# County of Santa Cruz

March 22, 2023

**Subject:** Public hearing to consider an appeal of Zoning Administrator's denial of Application 211316 for a proposal to construct an approximately 110-linear foot pin pier retaining wall, on-site with an existing single-family dwelling, located at 266 Cliff Court in Aptos.

C-1

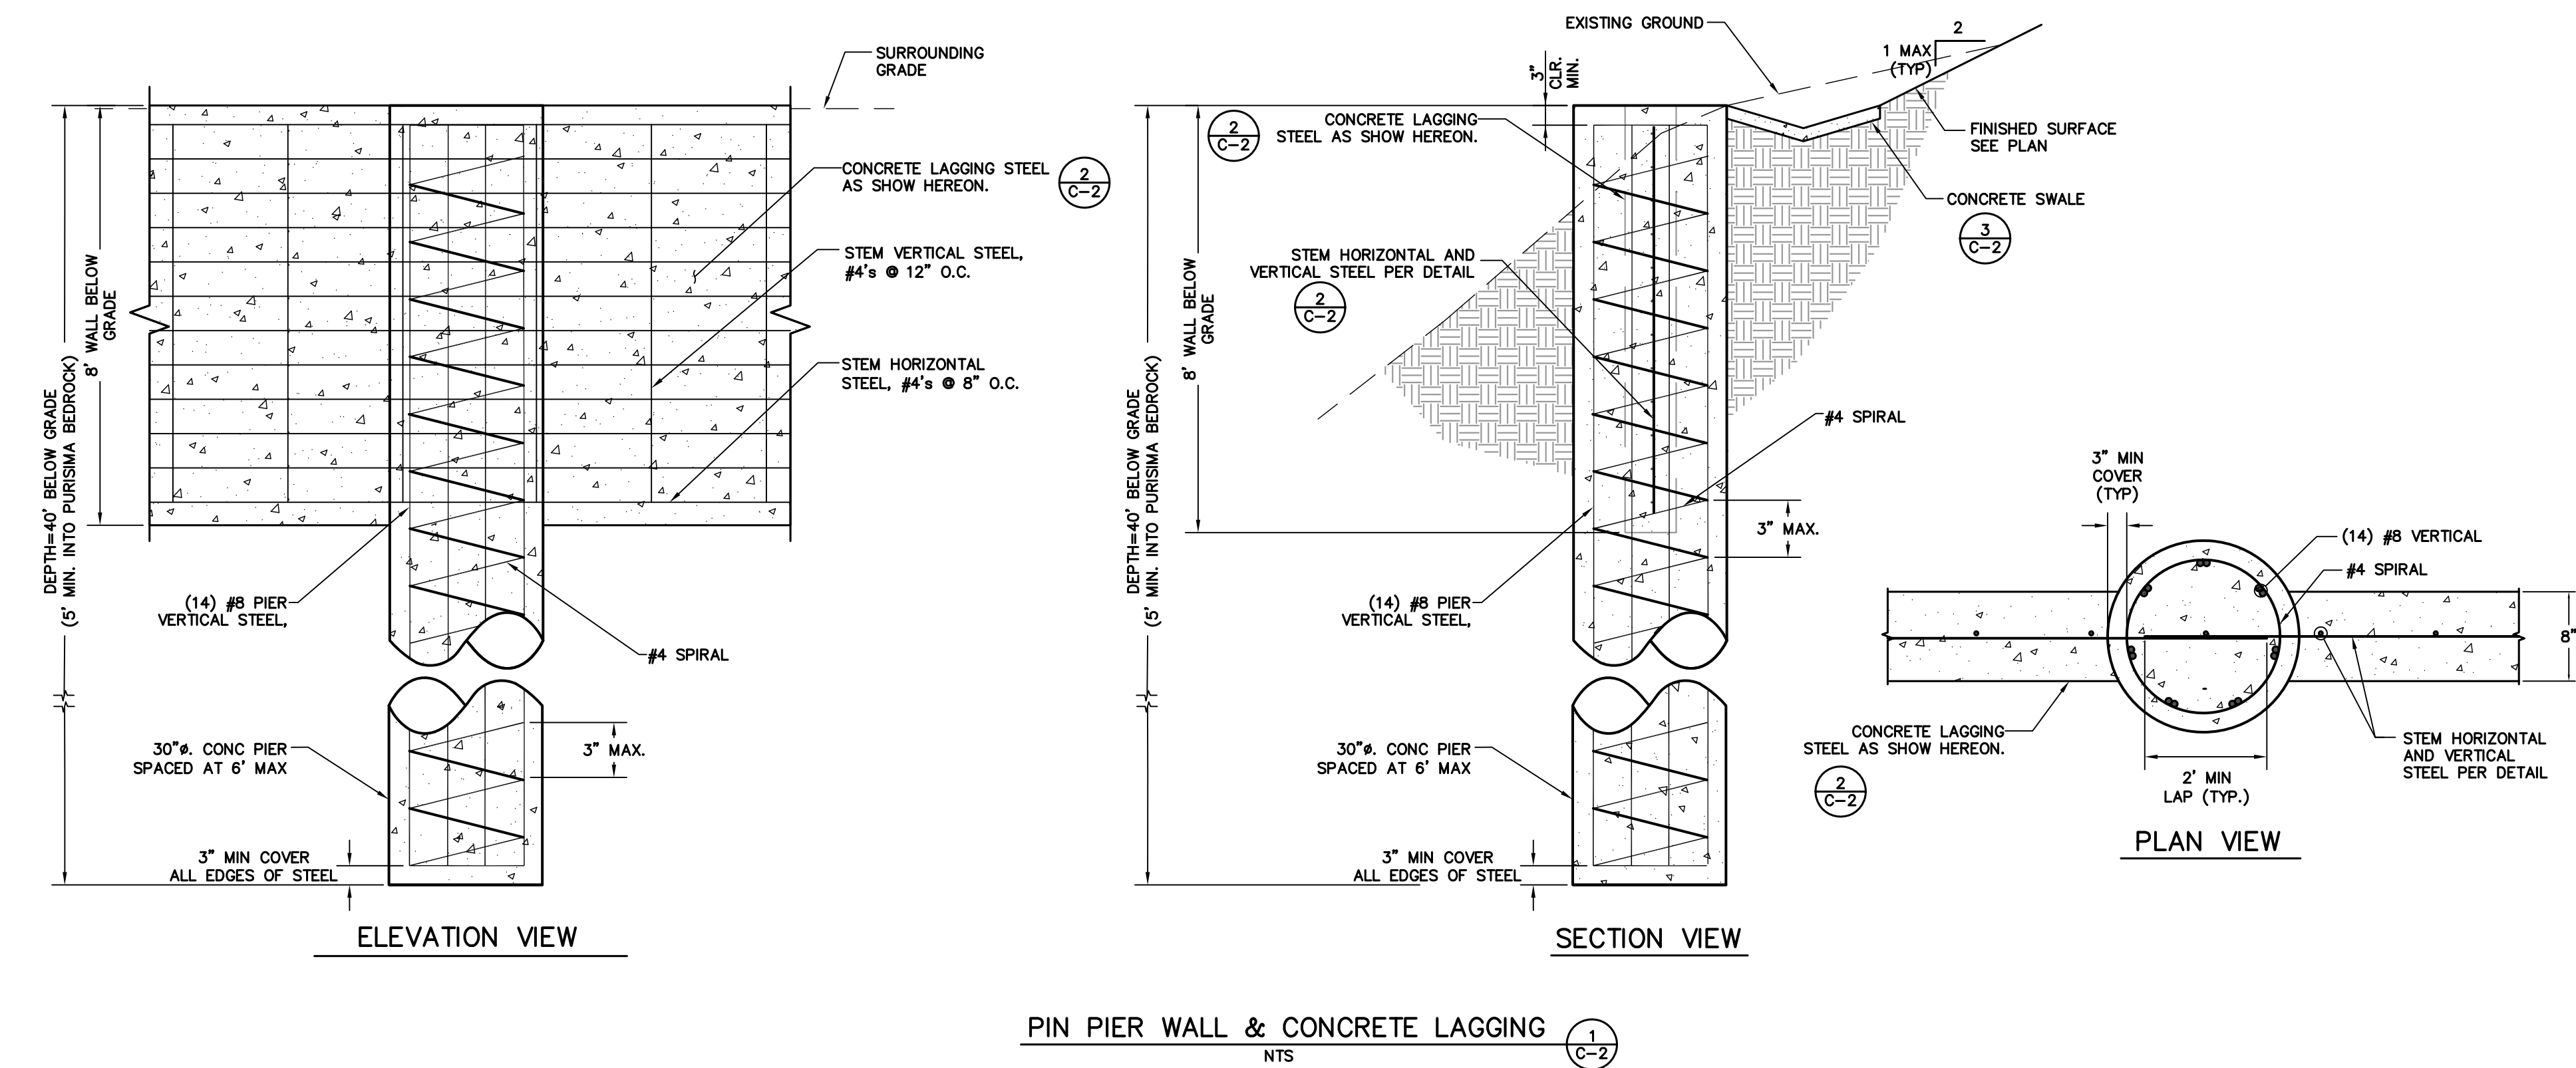
- Per Part 3 of the County Design Criteria, all development and redevelopment projects shall clearly show that proposed drainage patterns will not result in diversion of stormwater and will not adversely impact neighboring properties or drainage pathways.
  - The project design conflicts with Part 3 of the Santa Cruz County Design Criteria since diversion of stormwater is proposed and is therefore not in compliance. In order to bring the project into compliance with the County Design Criteria, the project needs to be changed so that it does not result in diversion of stormwater.
  - The County Design Criteria does allow for an exception to be considered for approval of diversion of stormwater. It states, “Diversion of runoff resulting in altered stormwater (drainage) patterns from the project site is not allowed without prior approval by the Director of Public Works.”

1. Provide topographic information that extends at least to the inlet on the property to the west that the proposed system will tie into. Provide detailed information about the diversion path (pathway, materials, slope, ownership, etc.) from the site to the point at which the path ties into the existing downstream path, or to the beach/ocean outfall, whichever is shorter.

2. Provide existing and proposed watershed area map/s. The existing map shall show the extent of on and offsite area/s that drain to the existing drainage facilities that will be removed as part of this project. The proposed watershed map shall show the extent of the on and offsite area/s that will drain to the proposed drainage system.

3. Provide a signed and stamped engineer’s analysis evaluating the adequacy of the condition, stability, and capacity (at least 25-year safe overflow is required) of the entire diversion path (see comment No. 2 above) – including private and public portions. Provide photo, video, and survey information used for the analysis. If any inadequacies are identified the applicant shall update the project scope to include upgrades/repairs/replacements

At the Zoning Administrator hearing, Mr. Machado accepted the proposed drainage plans with the following conditions:

1. Provide topographic information that extends at least to the inlet on the property to the west that the proposed system will tie into.
2. Applicant shall self-certify that the system has sufficient capacity for the proposed stormwater connection.
3. Applicant shall be required to certify in writing that they have sufficient legal rights to utilize the entire diversion path as proposed and shall further be required to execute a written agreement in a form acceptable to the County to defend, indemnify and hold harmless the County for all claims related to or arising out of applicant’s proposed use of the diversion path.”
4. Failure to comply with Conditions 1-4, as specified, will result in denial of the proposed diversion to a private system and the project shall be updated so that there is no diversion of stormwater.
5. No diversion onto Rio Del Mar Boulevard shall be allowed.
